R150

RETRO-REFLECTIVE DEVICES

Simplification stage 2

Table 1
List of retro-reflective devices and their symbols

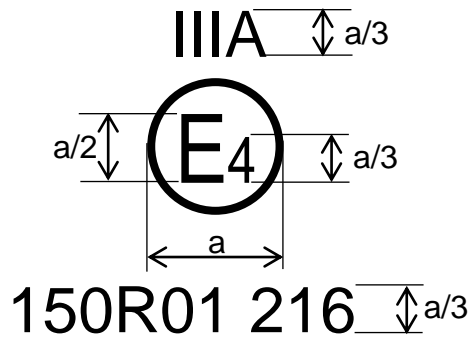
- ▶ In Table 1, to reduce the number of minimum sizes of “a”, the value “4 mm” should become “5 mm” and the value “12 mm” should become “8 mm”.

- ▶ Space removed for class IIIA
- ▶ Size aligned
- ▶ „104R“ removed
- ▶ „27R“ replaced by WT

CHANGES IN THE EXAMPLES OF THE APPROVAL MARKINGS

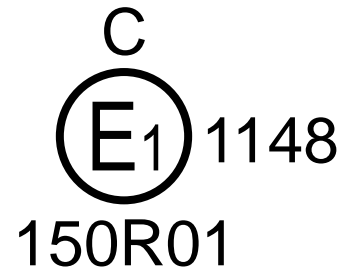
Space removed

EXISTING EXAMPLES IN R148 ANNEX 7 AND R150 (REAL SIZE OF THE MARKING)

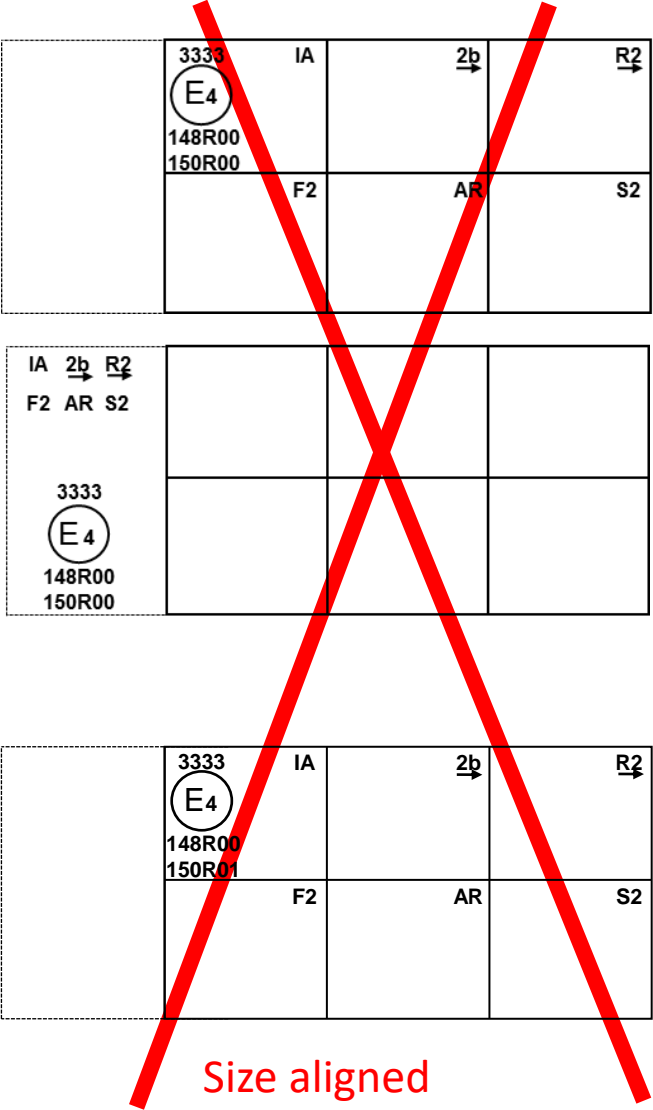
104R replaced by 150R

27R replaced by WT
